Access Compliance Report Public Rights-of-Way (Curb Ramps)

ADA ID: 501574A069D1 Ramp Type: Perp Initial Pass/Fail: Fail **Overall Compliance: No** Severity Score: 13.75

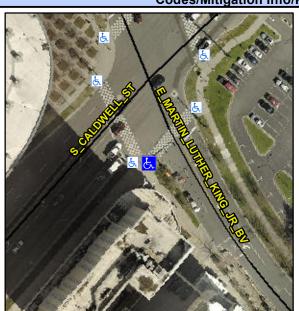
E MARTIN LUTHER KING JR BV Street 1 Name Stop Condition-Street 2 Signal Street 2 Name N/A Stop Condition-Street 1 N/A Possible Solutions: Remove & Replace Entire Ramp. Surveyor Notes: N/A PROW/ADA: Not Found, R304.2.2

Field Measurements/Component Compliance					
Compliance Description		Data	Comp	liance Description	Data
N/A	Ramp Length (in)	95.0	No	Ramp Slope (%)	10.0
Yes	Ramp Width (in)	48.0	Yes	Ramp XSlope (%)	4.6
N/A	Flare Type LT	N/A	N/A	Flare Type RT	N/A
N/A	Flare Slope LT (%)	N/A	N/A	Flare Slope RT (%)	N/A
N/A	Flare Traversable LT?	No	N/A	Flare Traversable RT?	No
N/A	Landing Length (in)	N/A	N/A	DWS Provided?	N/A
N/A	Landing Width (in)	N/A	N/A	DWS Contrast?	N/A
N/A	Landing Slope (%)	N/A	N/A	DWS Length (in)	N/A
N/A	Landing X Slope (%)	N/A	N/A	DWS Full Width?	N/A
N/A	Landing Curb? (Y/N)	N/A	N/A	DWS Offset (in)	N/A
N/A	Shared Landing?	N/A			
N/A	Gutter Ponding?	N/A	N/A	Gutter Slope (%)	N/A
N/A	Gutter Lip Ht (in)	N/A	N/A	Gutter X Slope (%)	N/A
N/A	Painted X Walk1?	Yes	N/A	Painted X Walk2?	N/A
	X Walk 1 Direction	To NE		X Walk 2 Direction	N/A
N/A	X Walk 1 Width (in)	144.0	N/A	X Walk 2 Width (in)	N/A
	X Walk 1 Slope (%)	2.1		X Walk 2 Slope (%)	N/A
